ADDENDUM NUMBER TWO (2)

Project: MTK – Camp Kamassa
Kitchen/Cafeteria and Infirmary Building
4002 Sumrall Road
Crystal Springs, MS
PN: 19104

FROM: Dean Architecture, P.A.
661 Sunnybrook Road, Suite 140
Ridgeland, MS 39157
(601) 939-7717

E001R

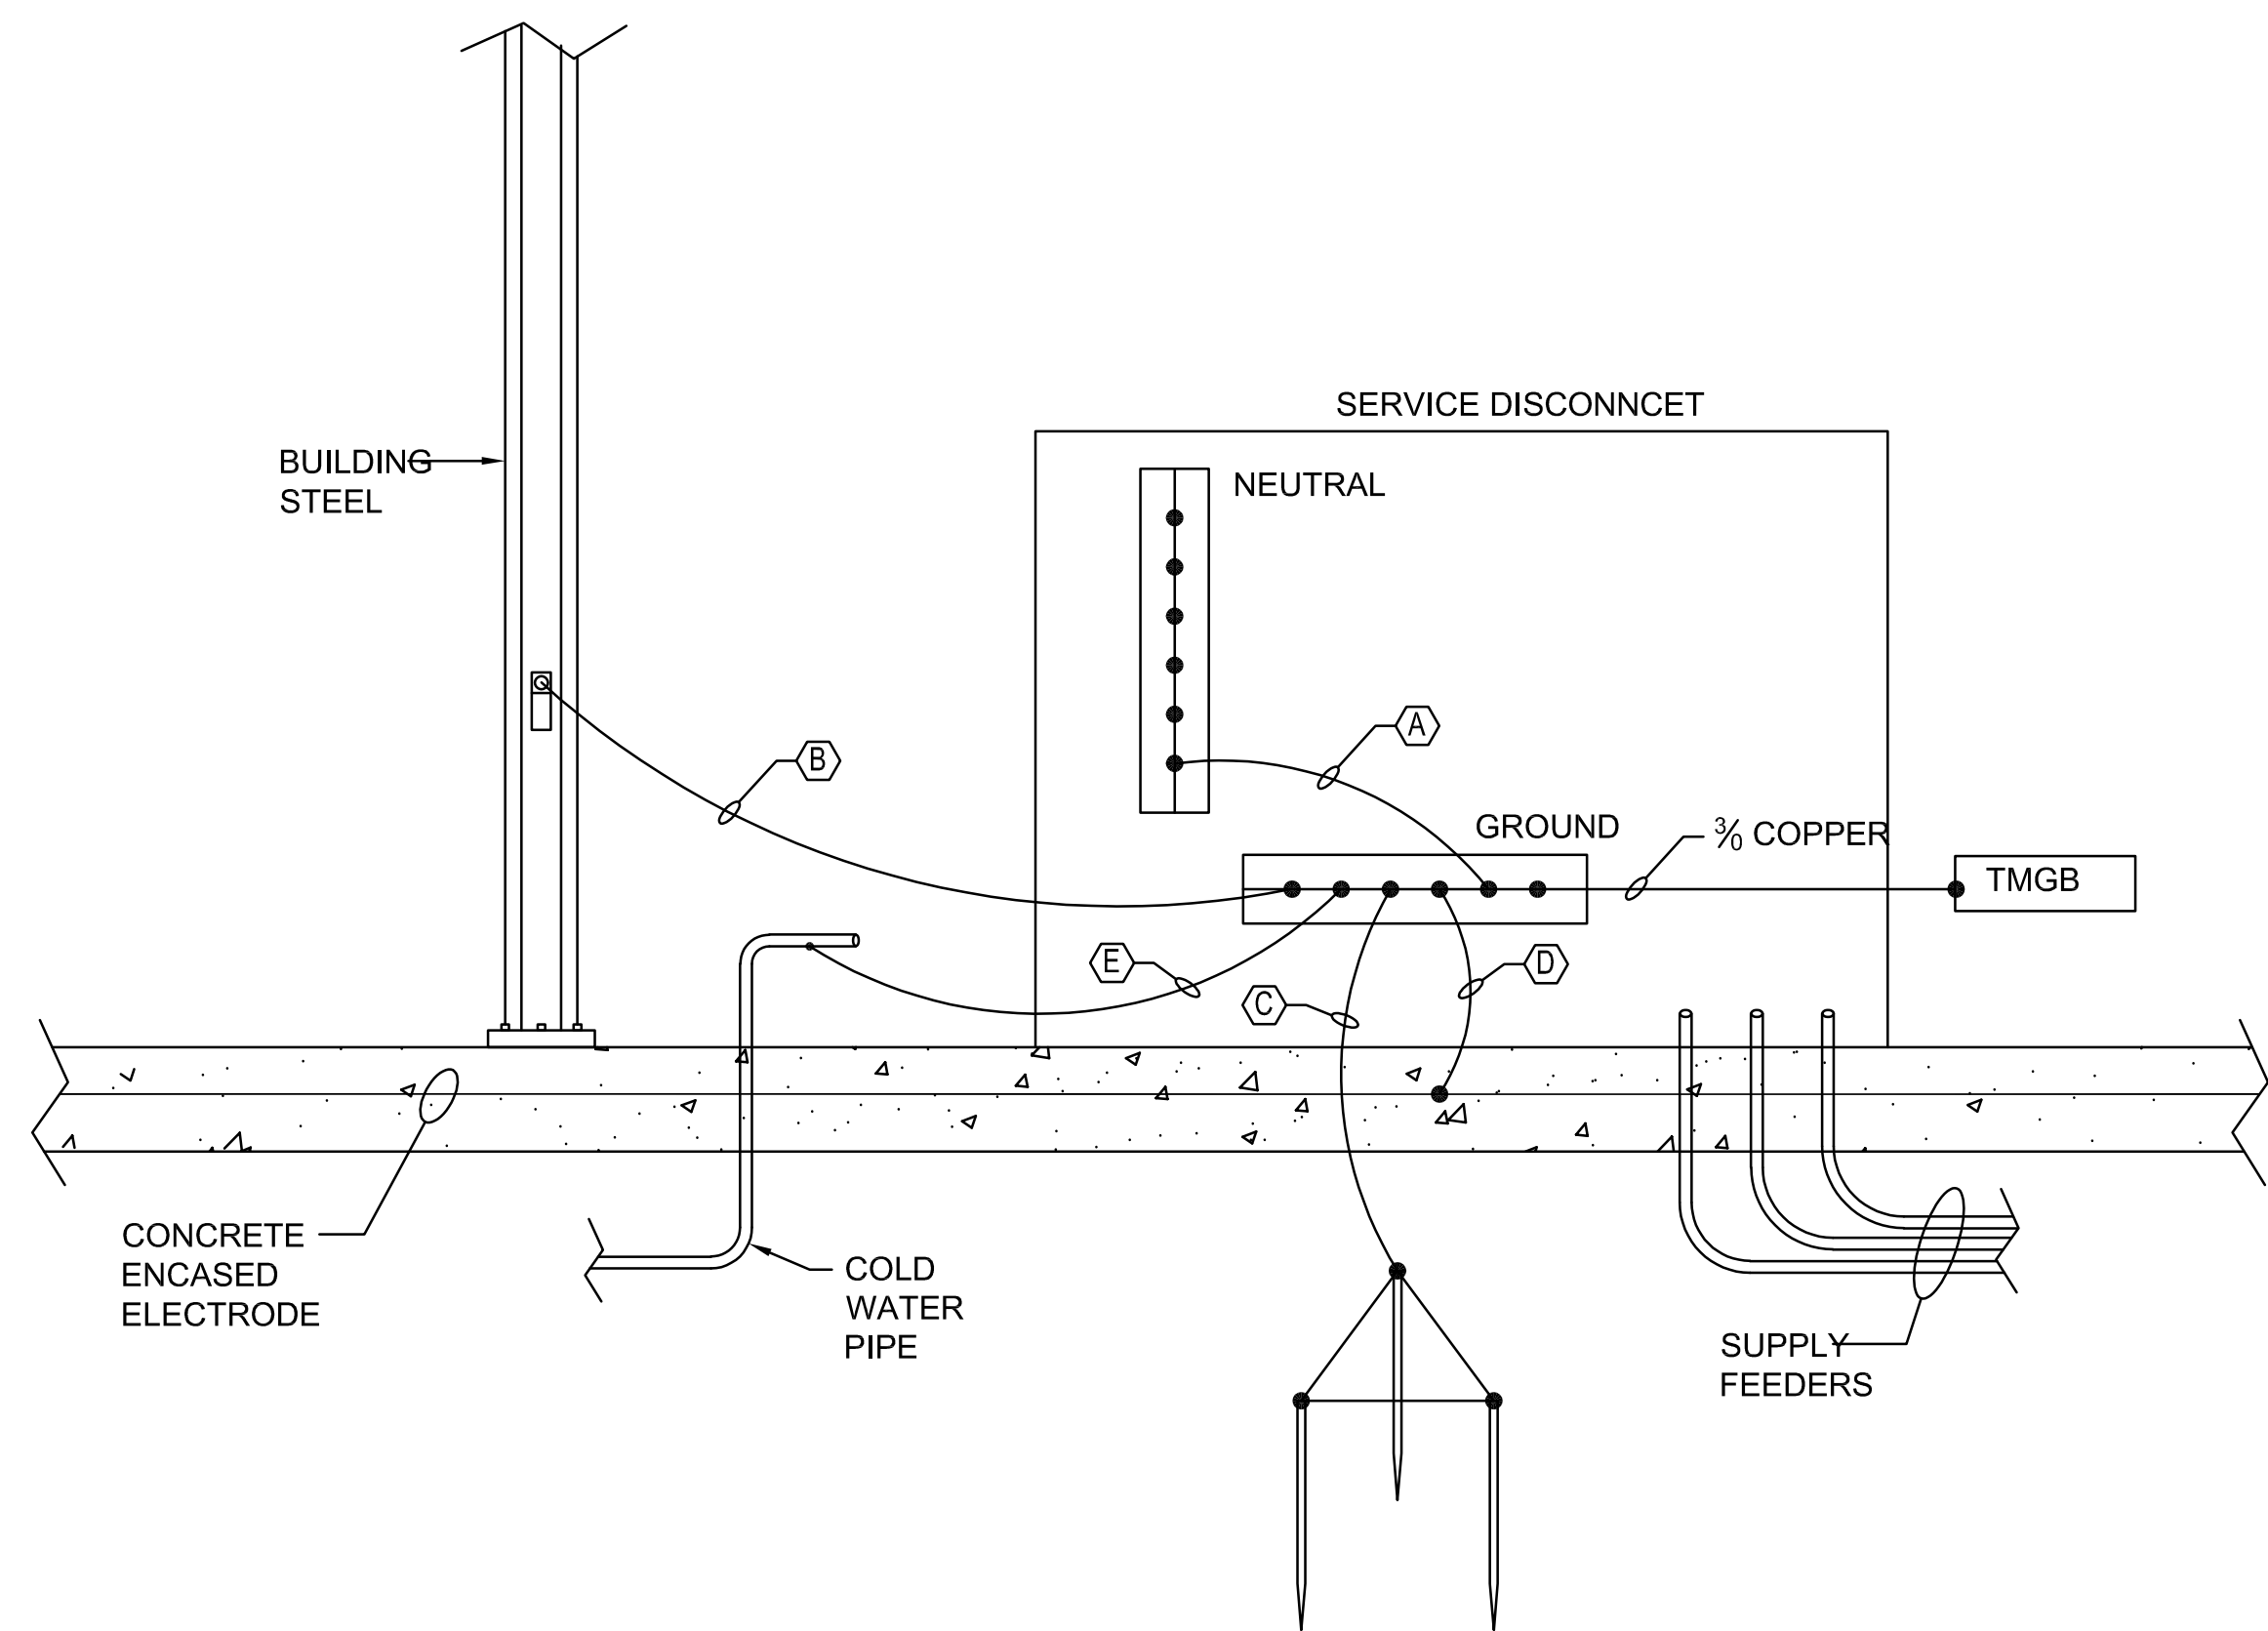
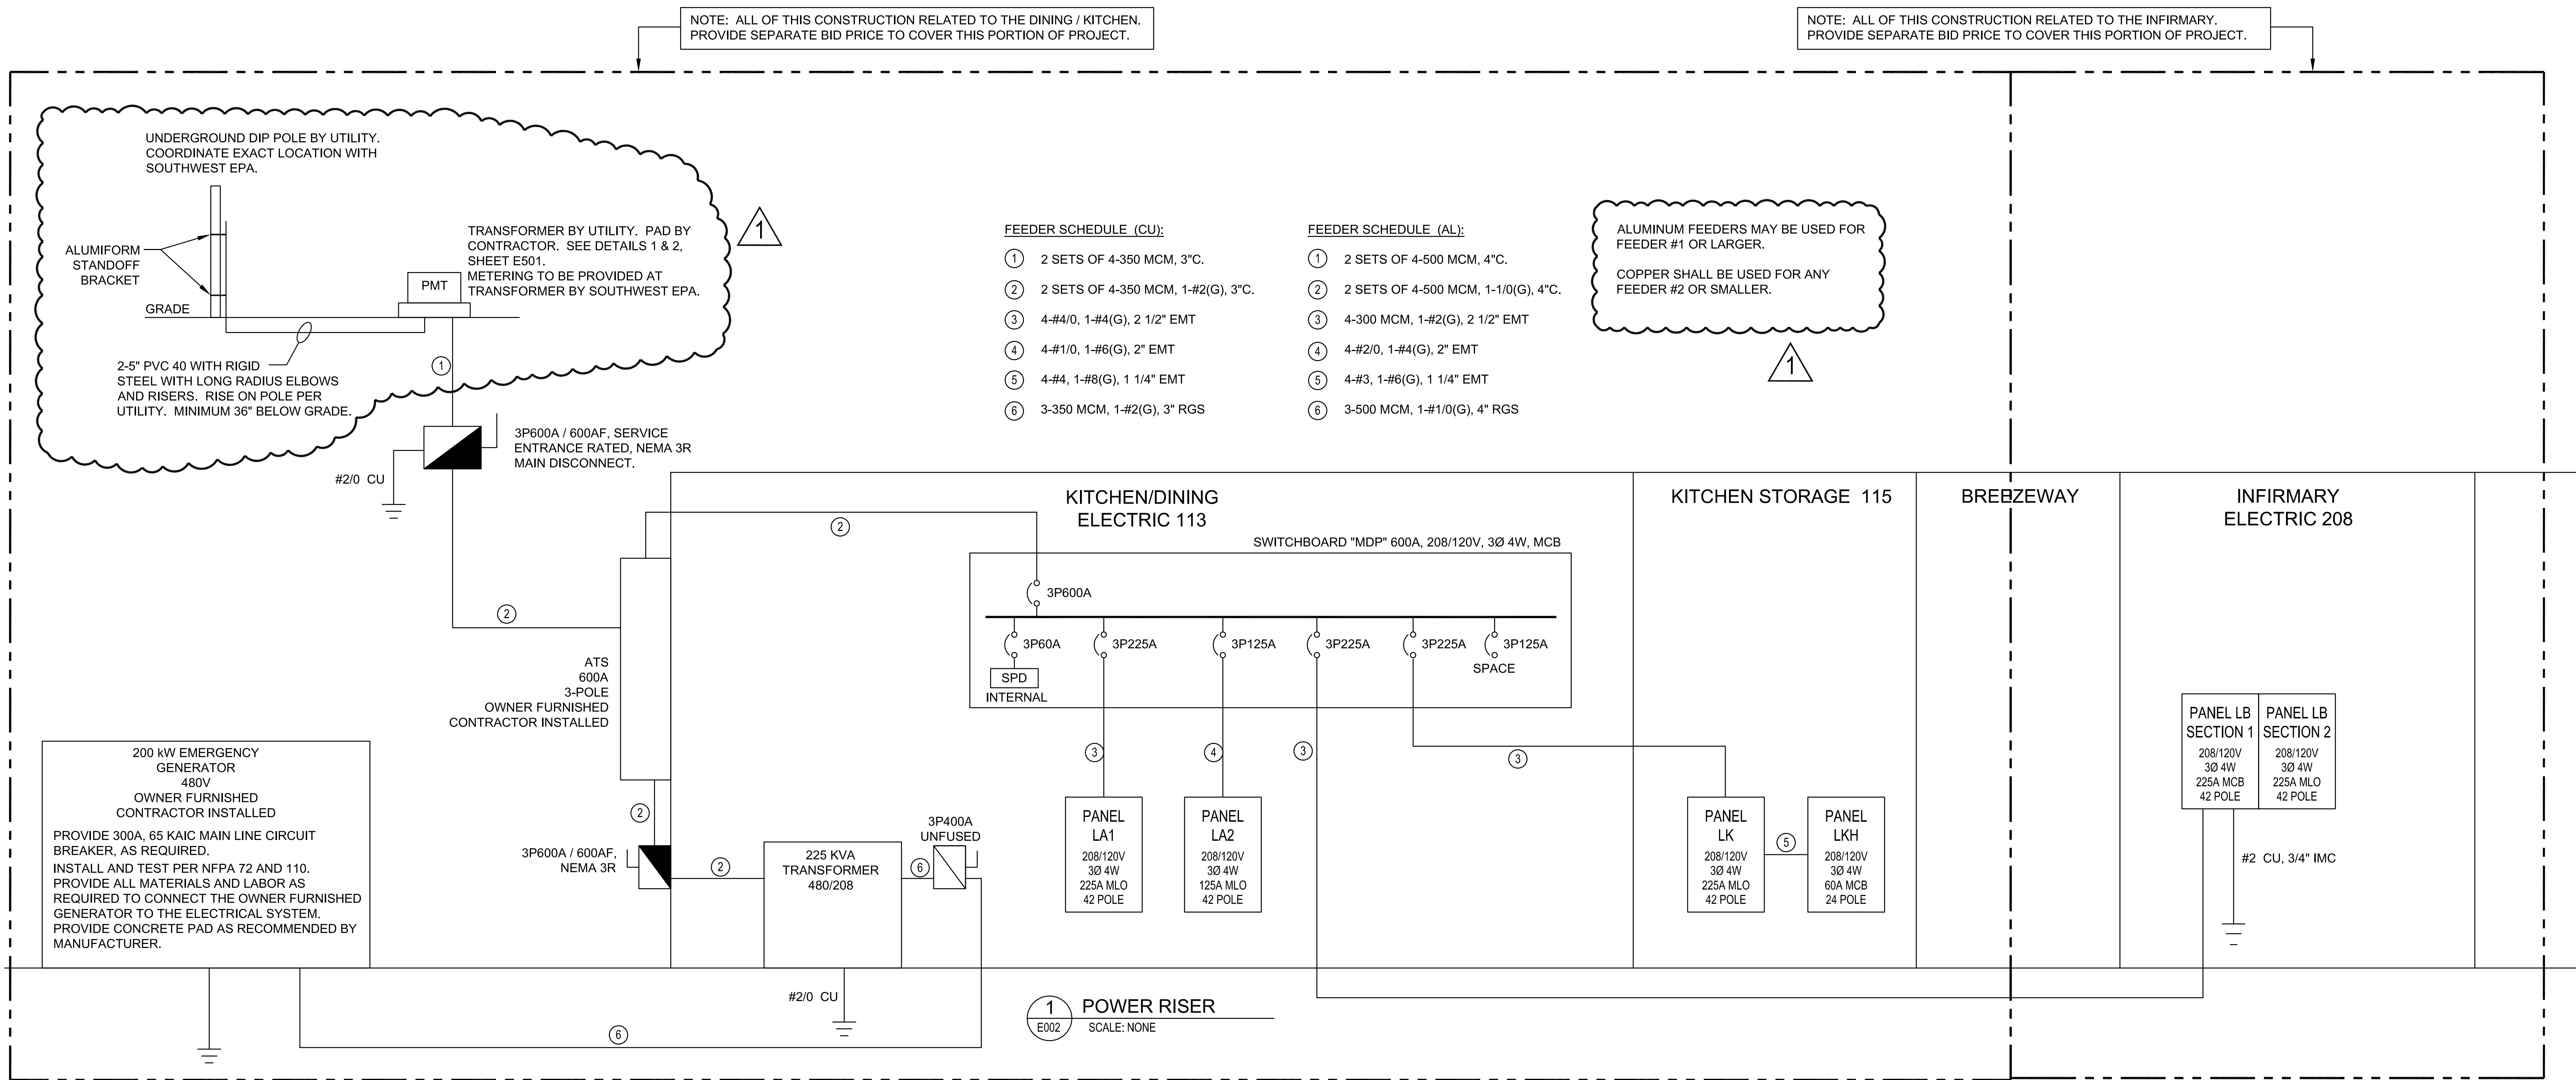
Item No. 5: Drawings, Sheet E001R, Electrical Legend: Clarified strobe description in Fire Alarm legend.

2 FIRE ALARM RISER
E003 NOT TO SCALE

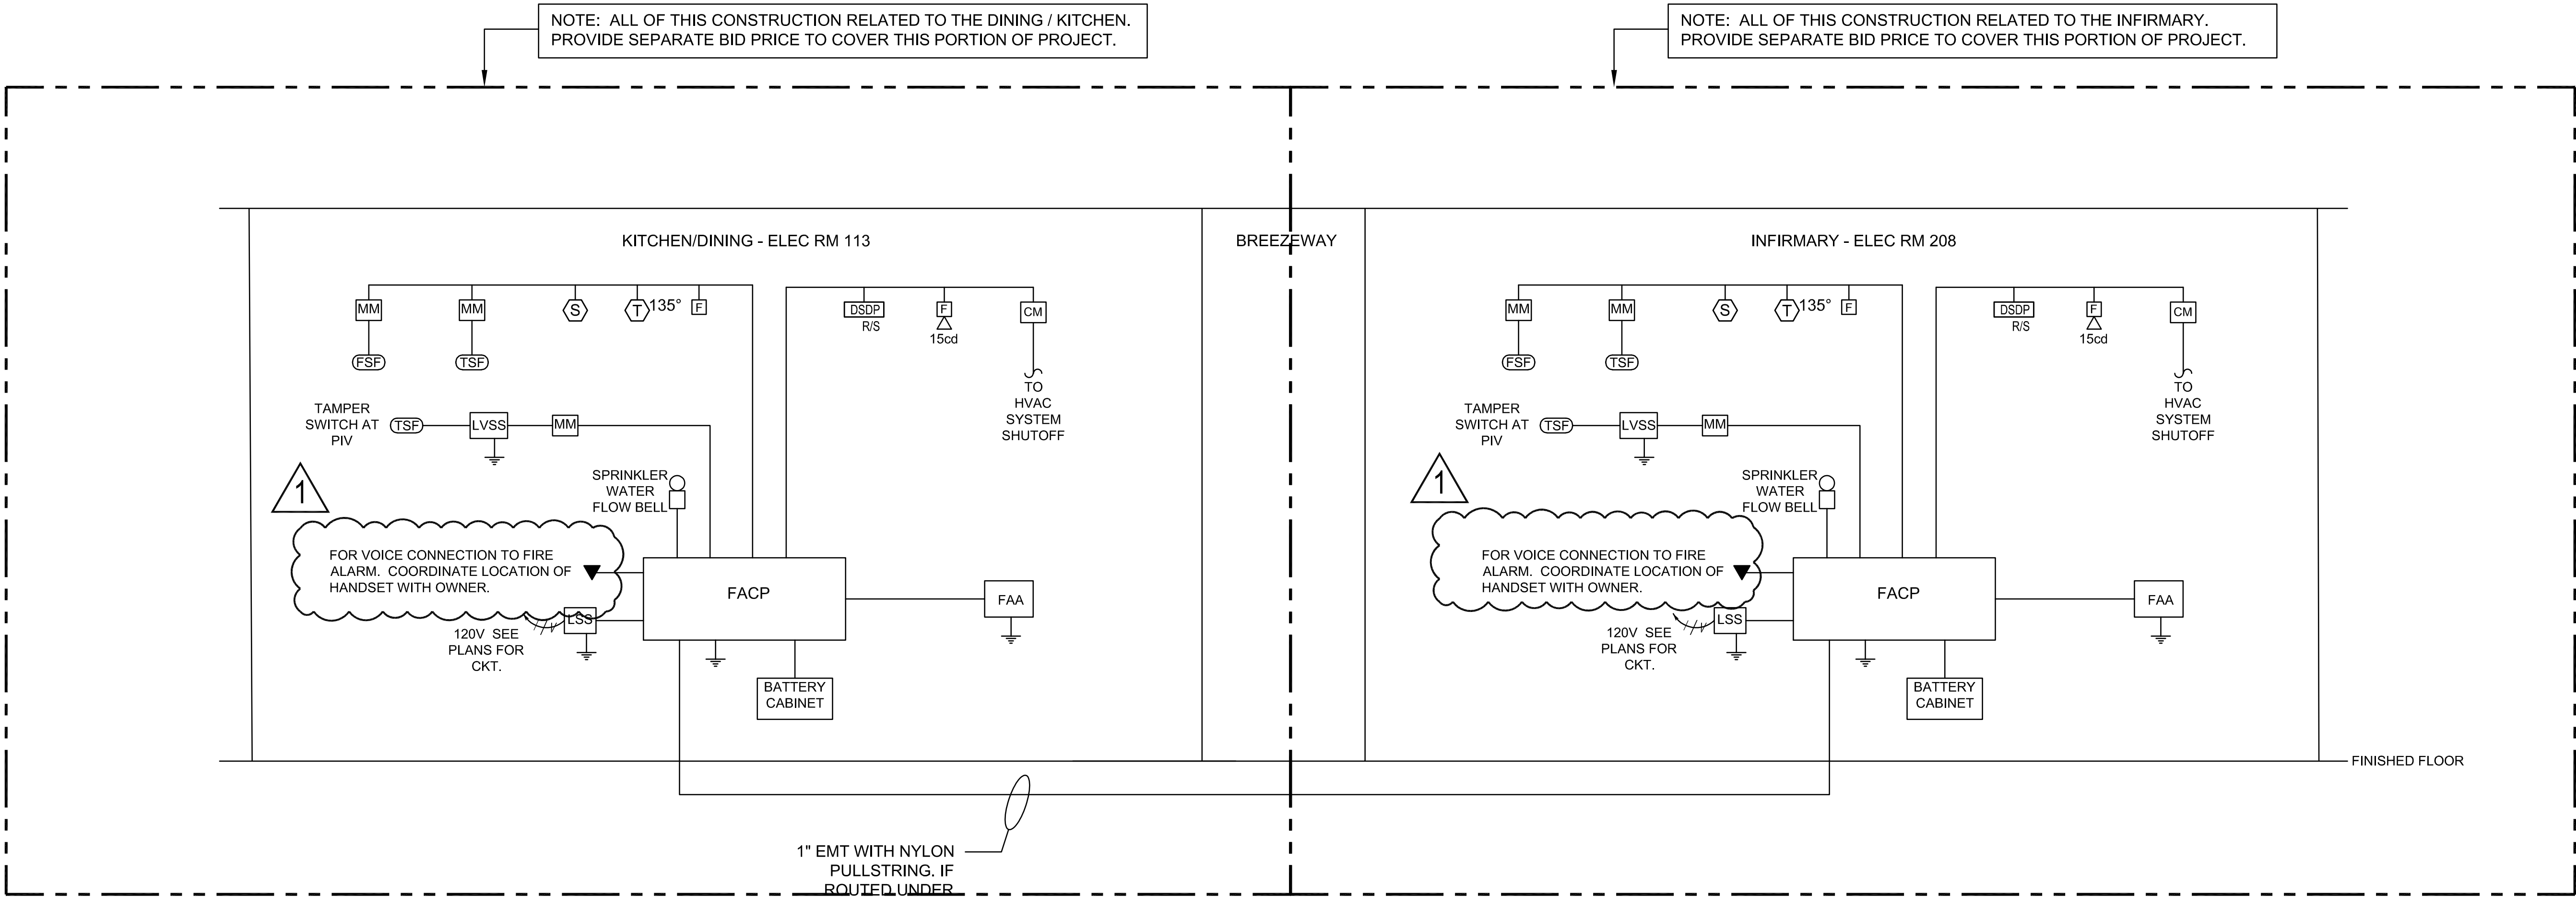
Item No. 7: Drawings, Sheet E003R, Fire Alarm Riser: Edited note referencing Voice connection.
